Re: Seven Brew Juan Tabo
2600 Juan Tabo Blvd. NE Albuquerque, NM 87112
Traffic Circulation Layout
Engineer's Stamp 08-27-25 (H22-D080)

Based upon the information provided in your submittal received 09-25-25, the above referenced plan cannot be approved for Building Permit until the following comments are addressed:

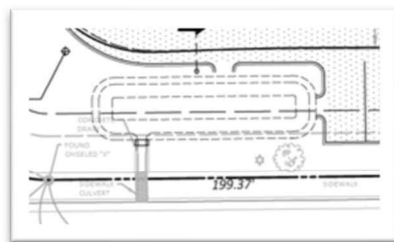
40. Label structure.

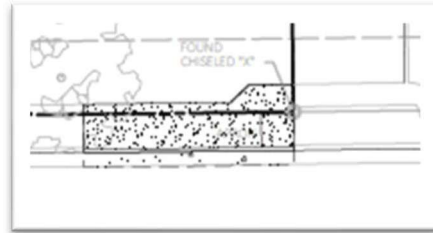
41. Is it the intention to close the existing driveway on Lexington Ave. NE?
 - If not, reevaluate drawing detail and show existing driveways serving properties across the street.

- If the intent is to close the access, label and provide proposed work, details, drawings, and pavement design reflecting appropriate City sidewalk standards DWG 2430.
